**BEFORE THE DIRECTOR OF THE  
DEPARTMENT OF PESTICIDE REGULATION  
STATE OF CALIFORNIA**

**In the Matter of the Responsible Farmers Coalition's**  
Request for Approval of  
Reduced Volatile Organic Compound  
Emissions Field Fumigation Methods

**DECISION**

SUBJECT: REVIEW OF "FIELD VOLATILITY OF METHYL ISOTHIOCYANATE AFTER APPLICATION OF METAM-SODIUM BY CHEMIGATION AND SHANK INJECTION COMPARING STANDARD WATER SEALING WITH PULSED WATER SEALING"

Figure 1. Recoveries of the laboratory spikes in analysis sequence

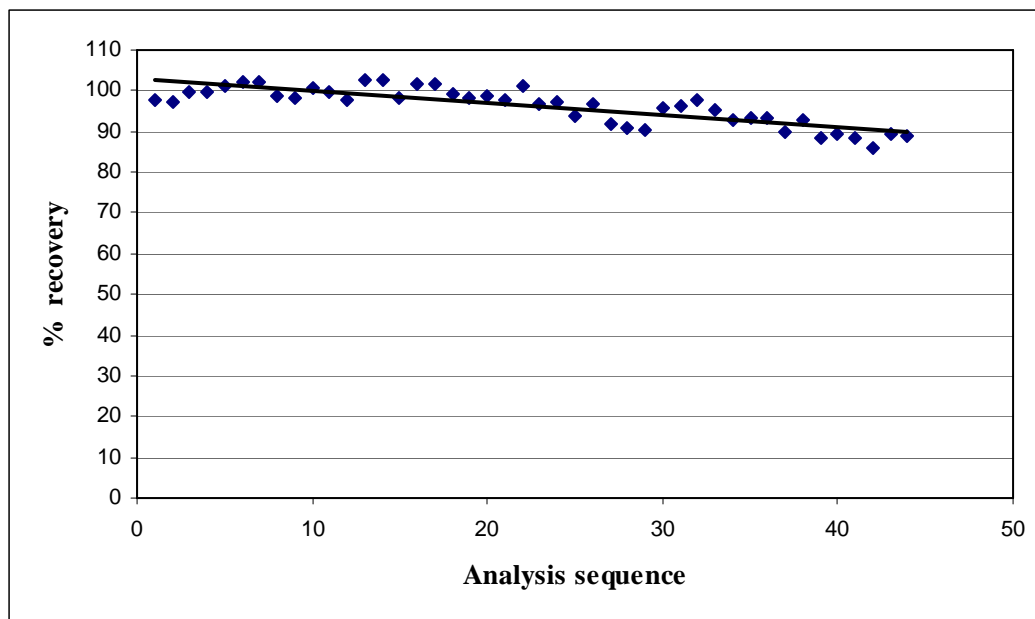
3. The results of the single concentration laboratory spikes show a declining trend with analysis sequence (Figure 1). This indicates a systematic bias that increases over time.

Figure 2. One copy of standard curves for laboratory analysis data calculation in Bakersfield study, 2007

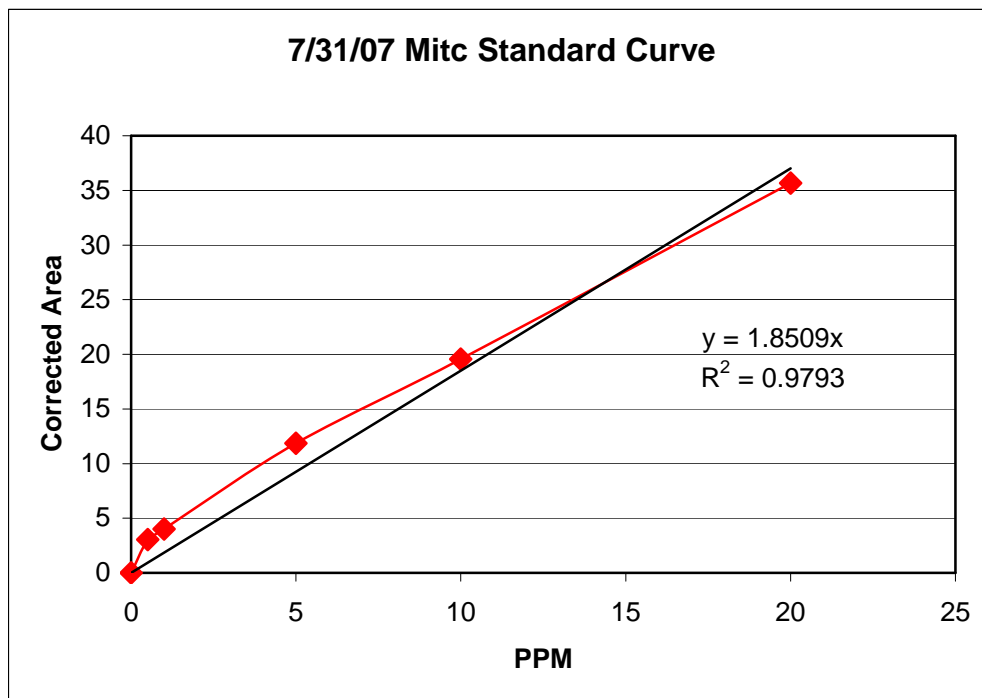
5. The laboratory standard calibration curves used to calculate the sample results were not linear ( $R^2=0.9793$ ) (Figure 2). For side-by-side comparison, a typical standard calibration curves ( $R^2=0.9997$ ) from the California Department of Food and Agriculture's laboratory is shown in Figure 3. Using a linear model for the nonlinear calibration curve leads to incorrect sample concentration results, particularly at low concentrations.
